Title: Proposal for Chiller No 1 alteration to Air Cooled DX System - Roof Layout
Client: Really Useful Group Theatres

Project: New London Theatre
Drawing No: S11340/9 Rev D
Air Conditioning Engineers
Tel: 01342 830600 Fax: 01342 830605
Email: service@comfort.uk.com

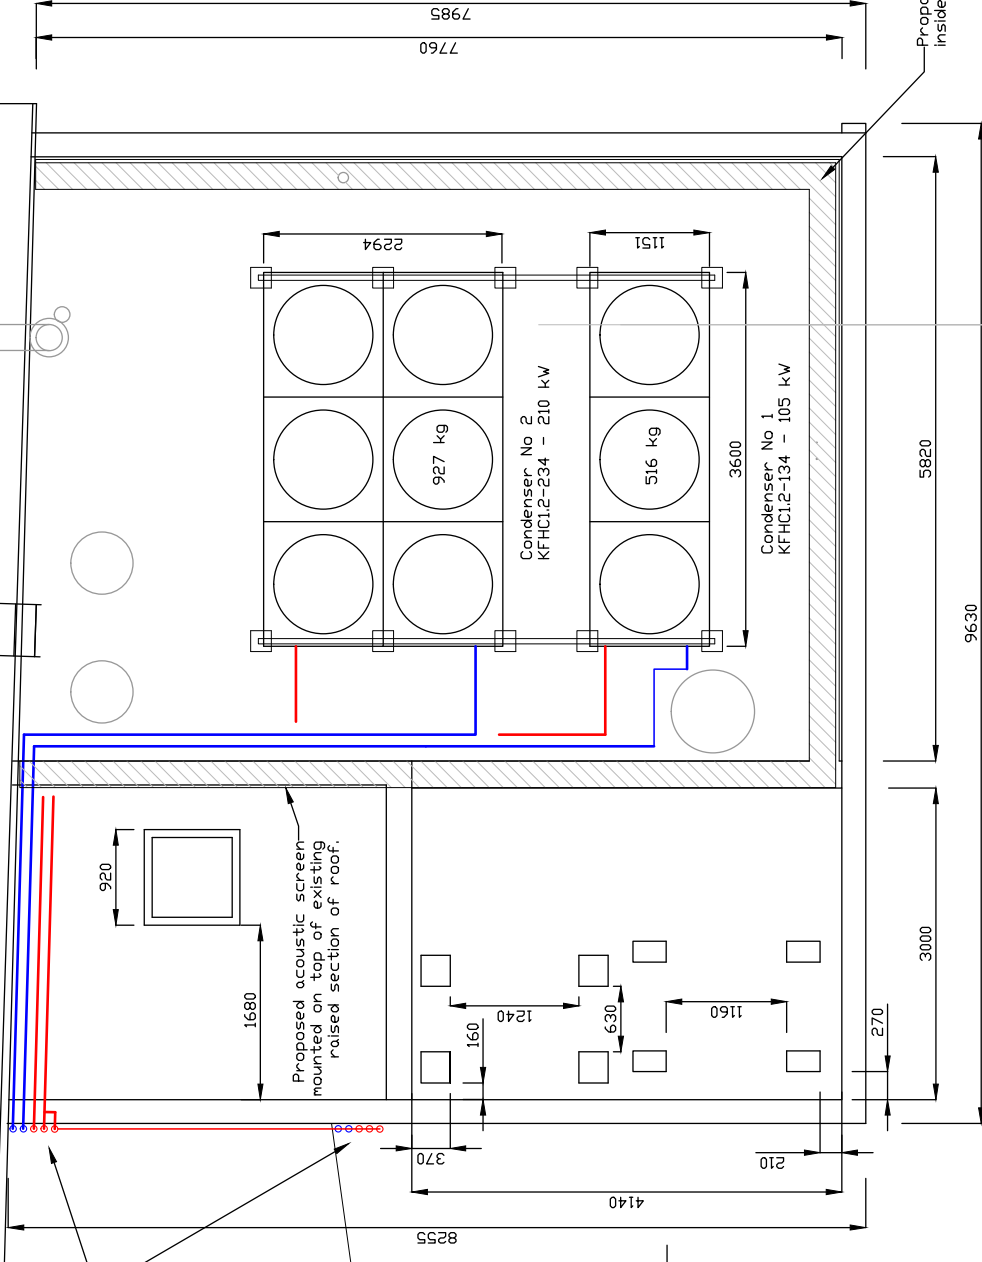
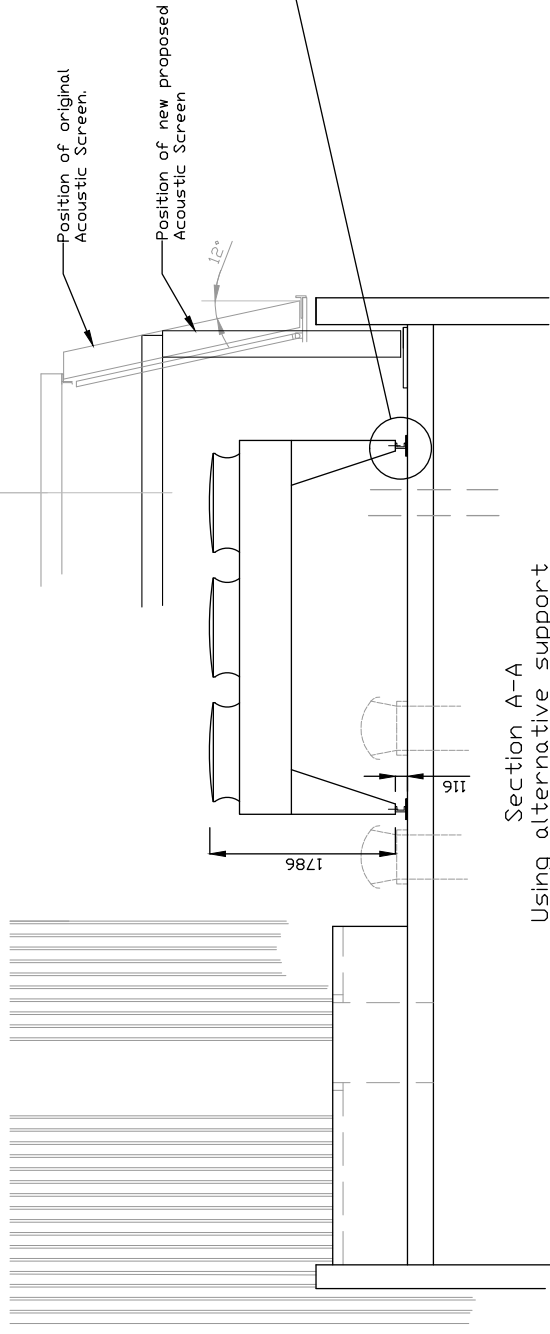
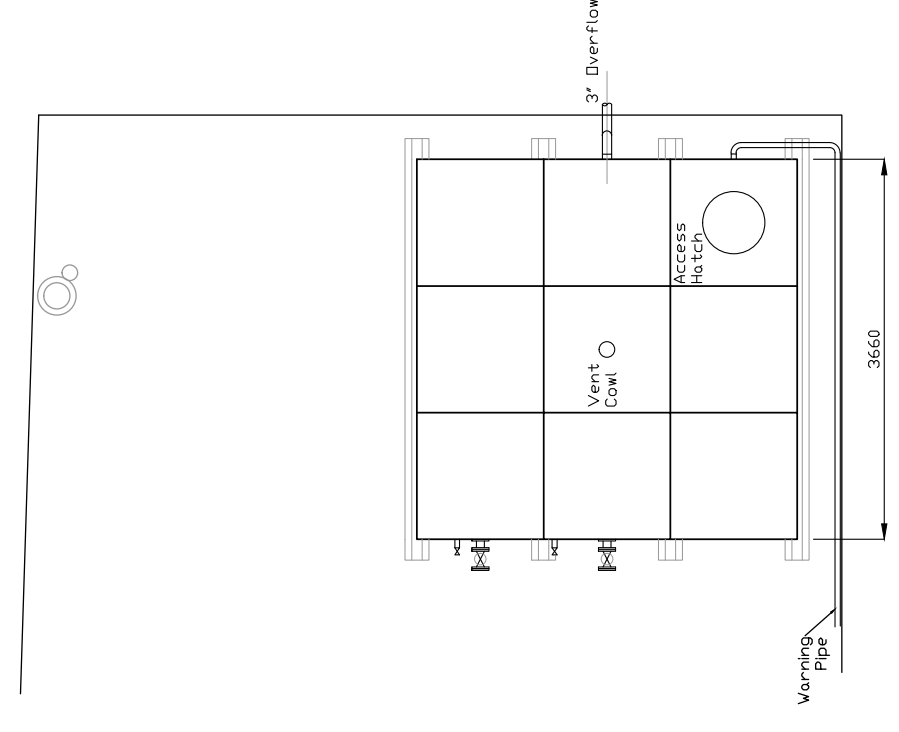
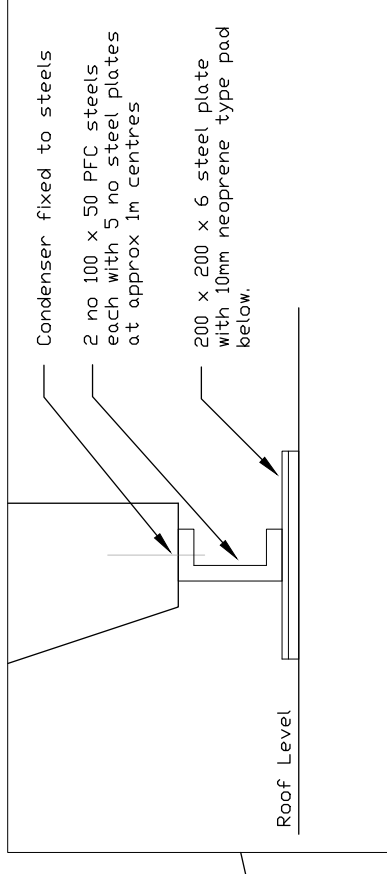
Rev C - Proposed acoustic screen shown to surround plant area only - 22 April 16

Rev B - New access hatch framed out with steel beams anchored to wall of tank room as advised by Fenton Holloway. - 15 April 16

Rev A - Condenser support method changed to suit structural engineers comments. Proposed modified acoustic screen shown - 13 April 16

Rev D - Proposed new Access Hatch omitted from contract - 29 April 16
